CLIENT Candida Baker			Cooper & Withycombe CONSULTING ENGINEERS Norwich House tel 01483 457373 14-15 North Street Fax 01483 566118 Guildford Surrey, GU1 4AF	
PROJECT Dickhurst Farm Petworth Rd. Chiddingfold, Surrey, GU27 8BG			ARCHITECT Stedman Blower Architects	
TITLE Frame Defects to East Elevation grid 9 and West Elevation grid 1			DWG. STATUS PRELIMINARY ● TENDER CONSTRUCTION RECORD	
DRAWN BY BFS CHECKED BY BA APPROVED BY DATE jan 22 DATE jan 22 DATE		PROJECT No. 21-2152 DRAWING No. 07 REV -		
BASE DRAWING SCALE 1: 50 @ A3		SCHEDULE SHEETS

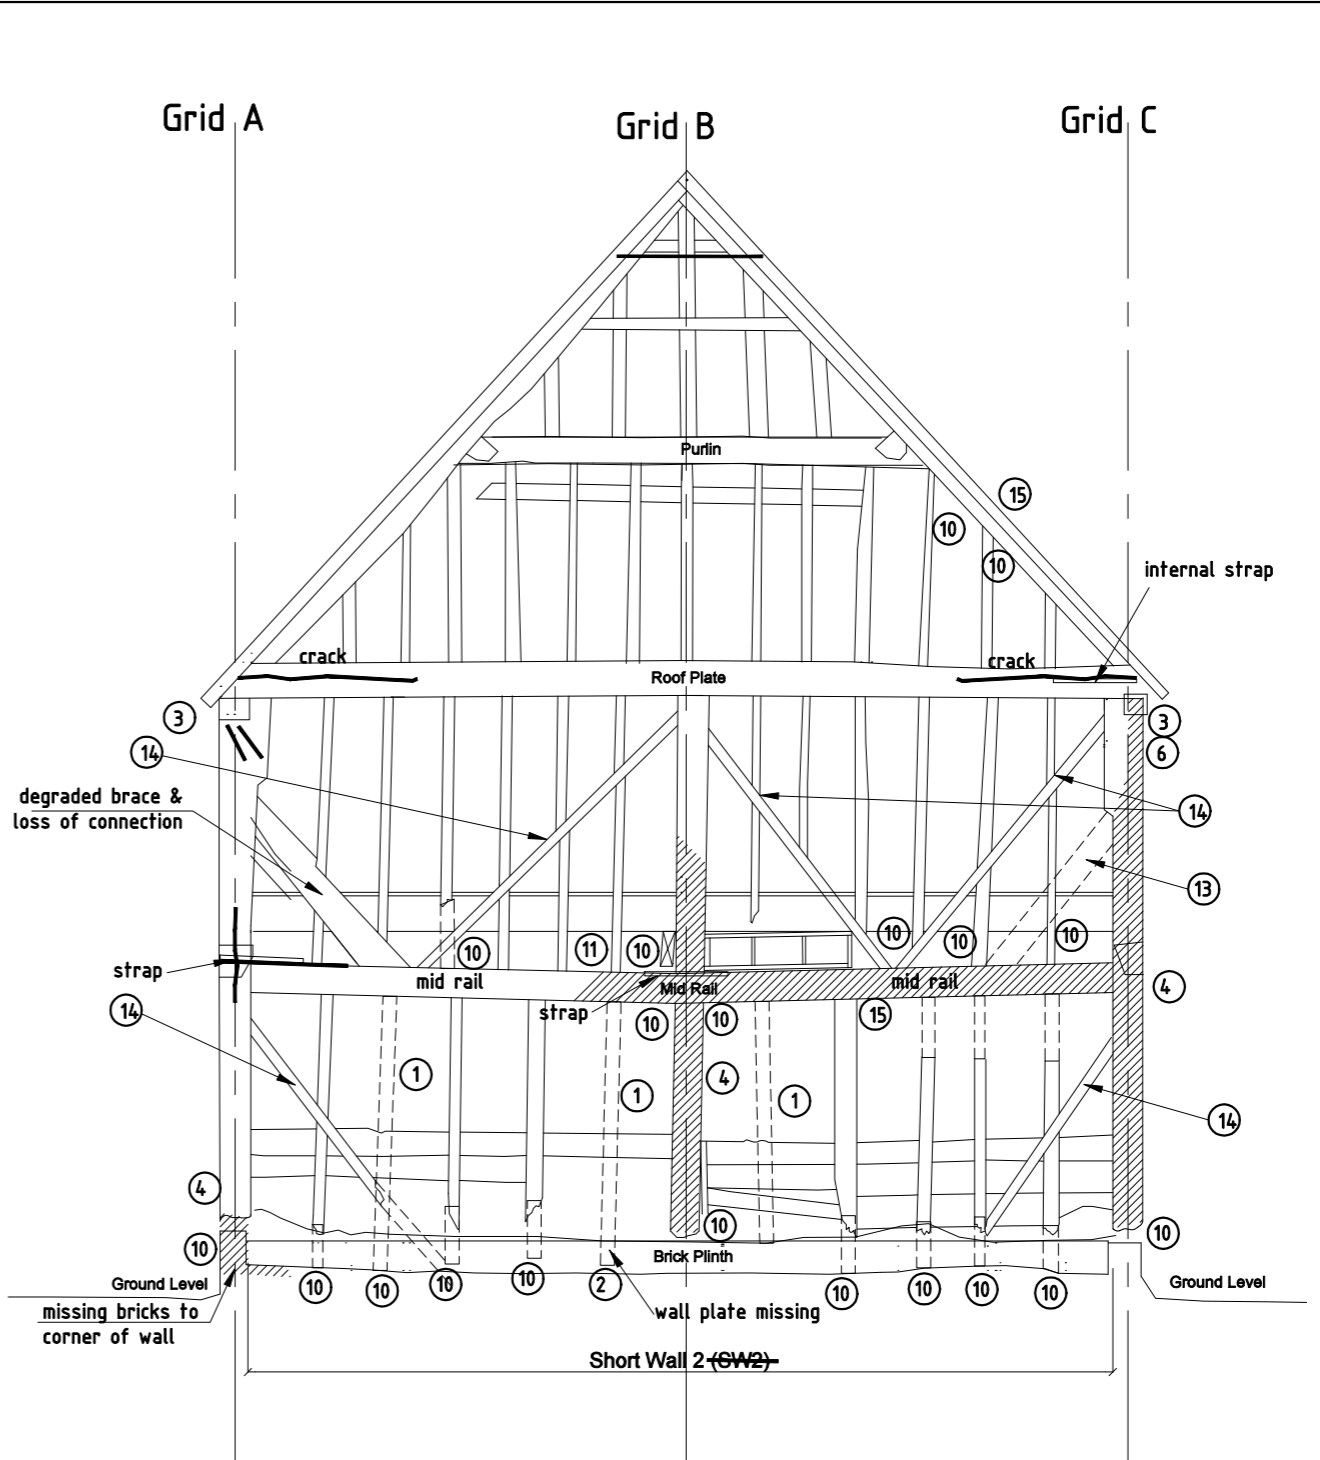
- 1 Missing stud
- 2 wall plate degraded (or missing)
- 3 Split at top of post
- 4 post severe decay
- 5 section of post severe decay
- 6 large hole to front
- 7 large hole to u/s beam
- 8 face severe decay
- 9 large hole to rear
- 10 loss of section and connection
- 11 loss of connection
- 12 loss of section
- 13 missing brace
- 14 added brace
- 15 beam severe decay
- 16 missing rafter
- 17 defective purlin connection
